### Comments on the previous Automotive Profile Outline Suggestion

Max Turner, Ethernovia 2023-02-21

**Suggestions for Automotive Profile outline**

Norman Finn Huawei Technologies Co. Ltd dg-finn-auto-prof-outline-0119-v02

#### 1. Separation by VLAN

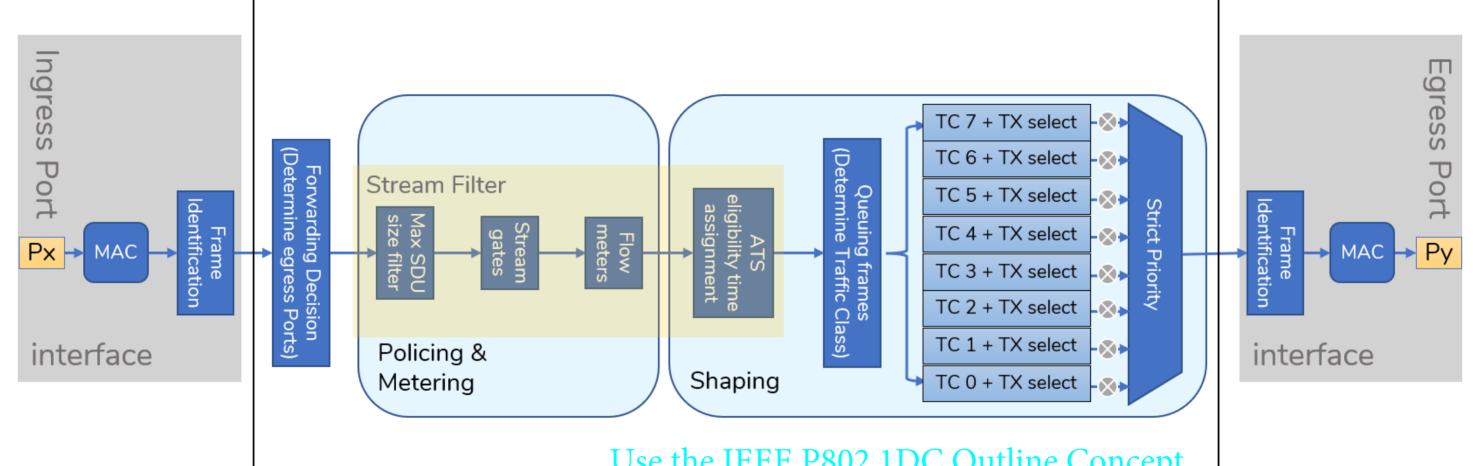
Focus on EISS

and Frame Identification from |CB|

Use the IEEE P802.1DC Outline Concept to describe the functional blocks!
